**Terror Lake Hydroelectric Project, Falls Creek Diversion Tunnel
Hydraulic Analysis**

Subject: Transmittal of the Hydraulic Analysis and Recommendations for the Repairs to the Terror Lake Hydroelectric Project - Kodiak Electric Association, Inc. - Kodiak Island, Alaska

**Terror Lake Hydroelectric Project
Falls Creek Diversion Tunnel
Hydraulic Analysis**

Terror Lake Hydroelectric Project Repair of Falls Creek Diversion Works

Figure 1

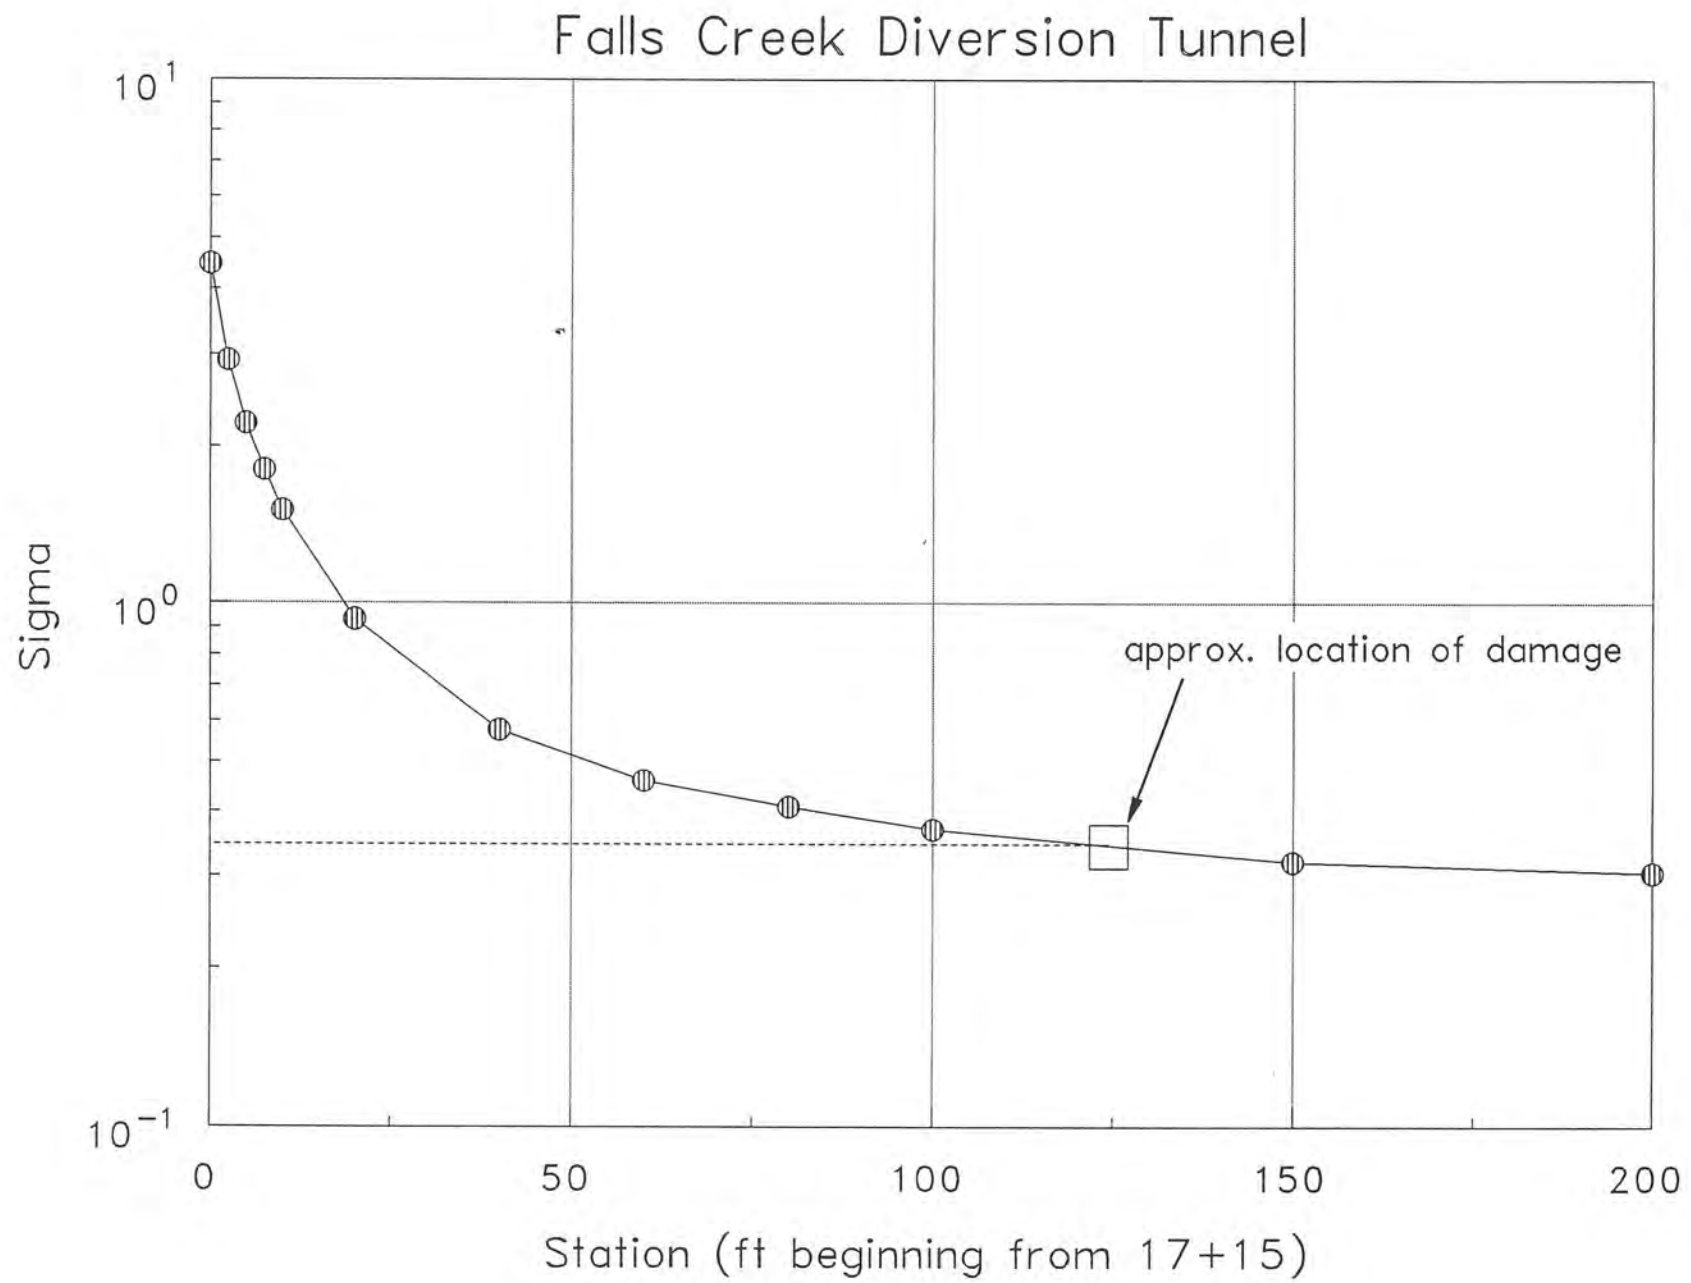
Results of this analysis showed that for a relatively smooth surface (rugosity = 0.002 ft) the cavitation index at the station where the damage has occurred was about 0.35 (figure 1). With a rougher surface, which would be more characteristic of an unlined rock tunnel, the cavitation indices are even higher. However, the velocities at the damage location are on the order of 75 feet/second. Taking into account the highly fractured rock which was discovered in this area during construction, hydraulic mining due to the high velocity jet along the tunnel surface is the probable cause for the existing damage and rock fall. High pressures can be generated in cracks and gaps due to high velocity flow (Hepler and Johnson, 1988). If the pressures are high enough (or the rock blocks small enough), material can easily be lifted from place and removed. Once this process begins, further damage occurs due to the increased hydraulic energy dissipation until an equilibrium is reached based on flow conditions and material properties in the area of concern.

The damaged region in the Falls Creek Diversion inclined shaft is exposed to very high water velocities during operation. Due to this high velocity flow, it seems appropriate to bring the tunnel profile back to its original diameter. Zones of fractured rock downstream from the repaired area should be protected to reduce the chance that future erosion will take place. An analysis and recommended method to repair the damaged area of the Falls Creek inclined shaft is attached.

Figure A.2 Profile Falls Creek Diversion (from Kodiak Electric Association, Inc. drawing TL-31-003)

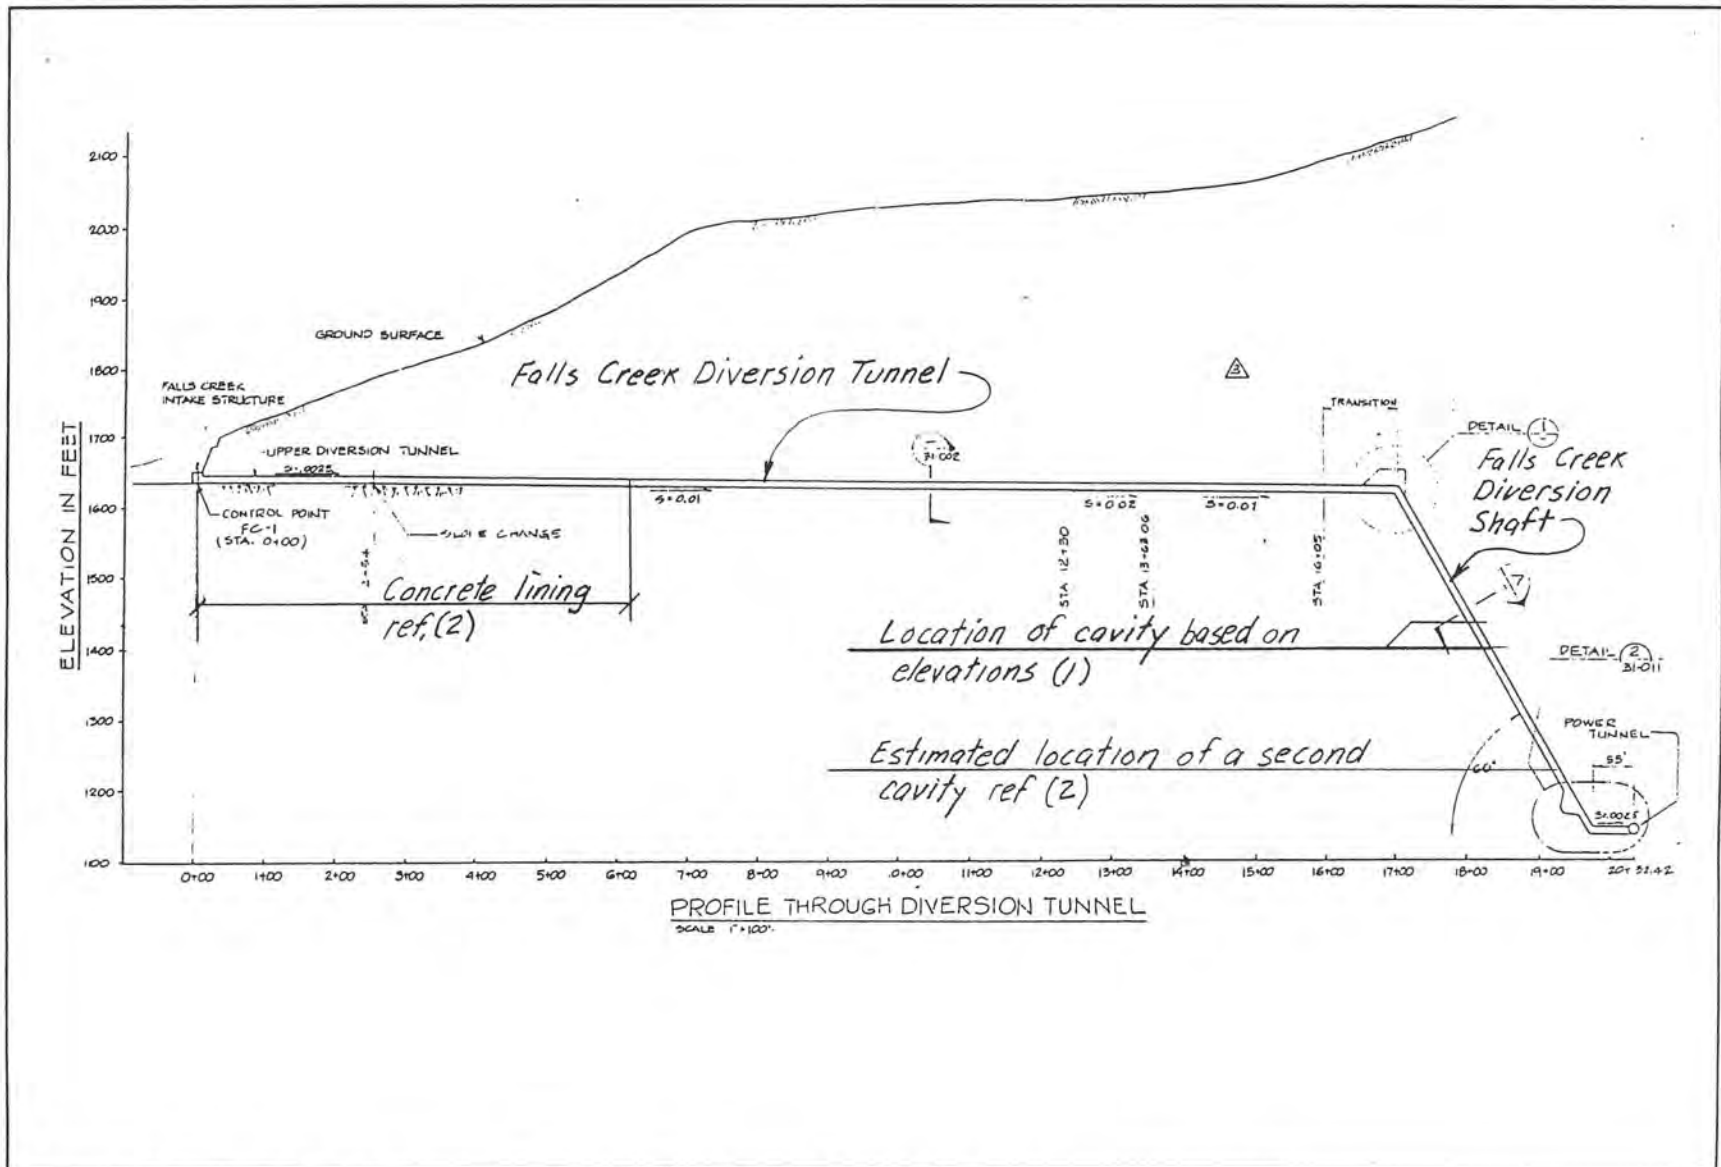
Another area of erosion in the shaft was described in the video narrative but was not photographed. If the damage is similar to that shown in Figure A.5, this area should also be repaired. This location is shown approximately on Figure A.2.

A second cavity mentioned in (2) should be investigated for possible repair.

Figure A.6 Recommended Repair

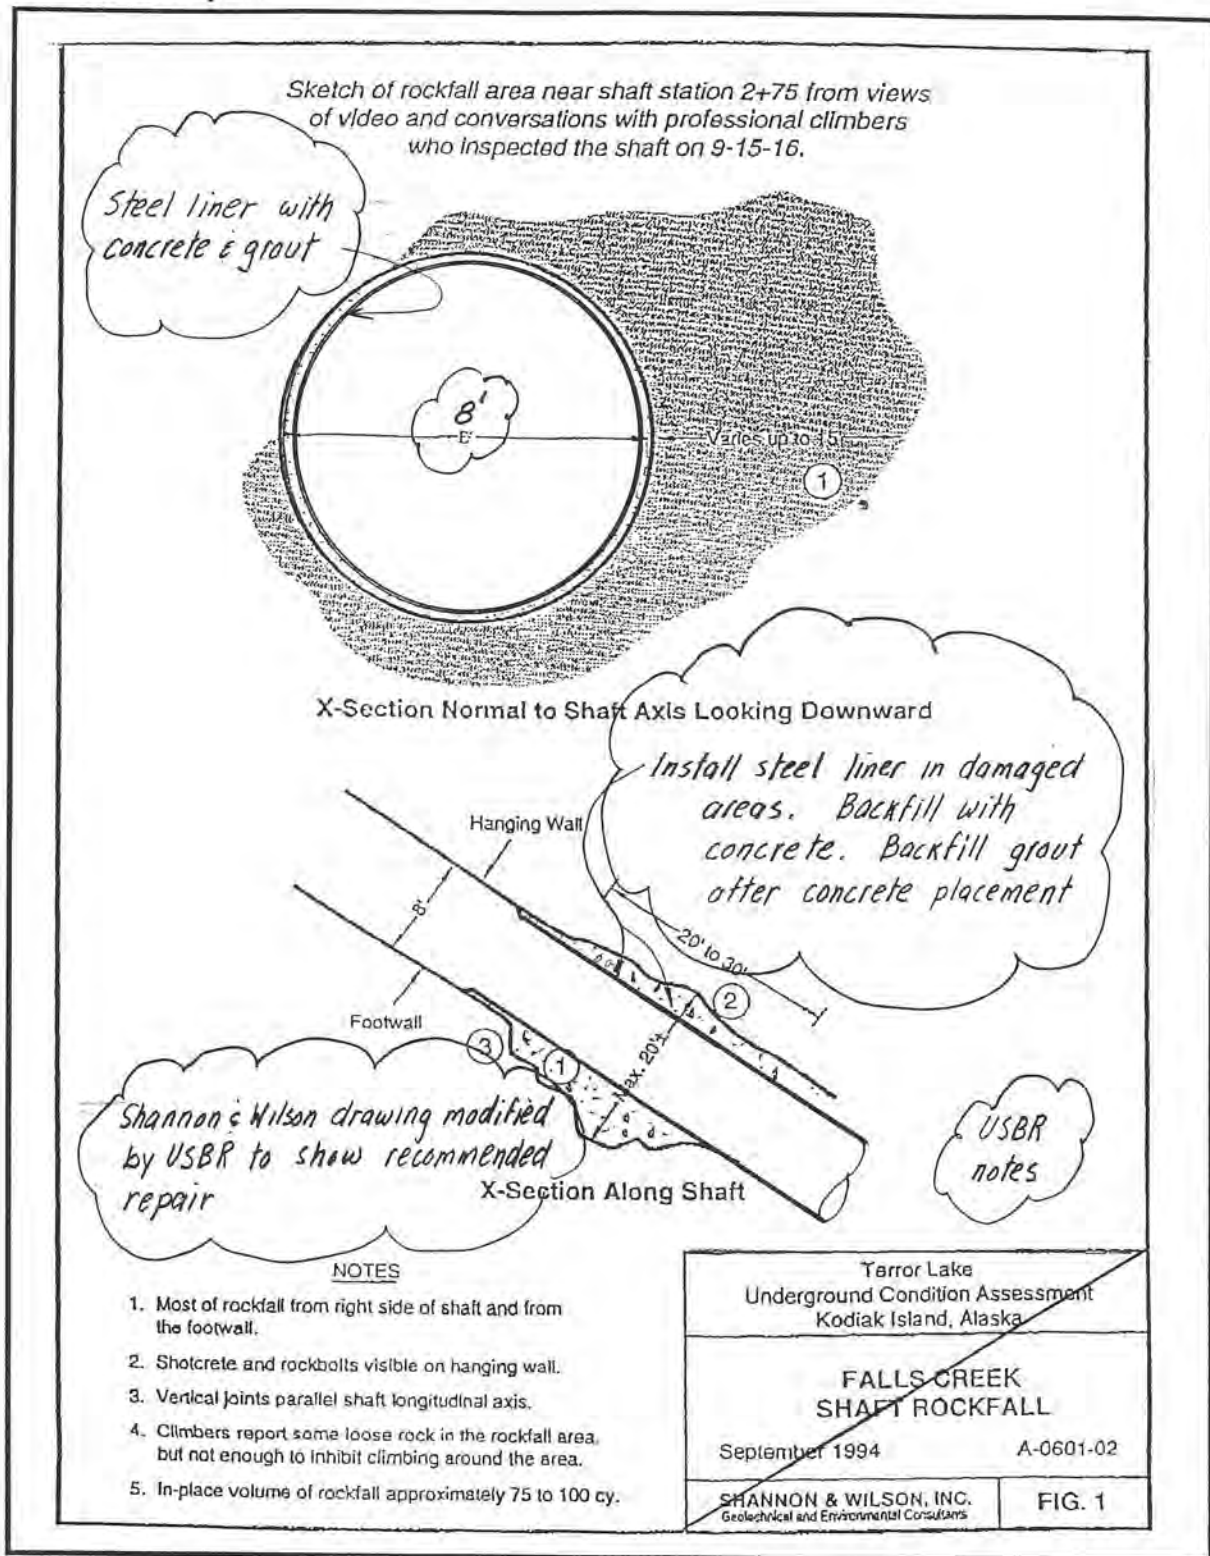
A steel liner placed through the damaged area and backfilled with concrete will provide the maximum resistance to erosion and will be cost effective in the long term.

We recommend repair of Falls Creek Diversion Shaft near elevation 1400 using a steel liner with erosion resistant lining. The steel liner should be backfilled with concrete and backfill grouted near the top of the installation. Figure A.6 shows the recommended repair.
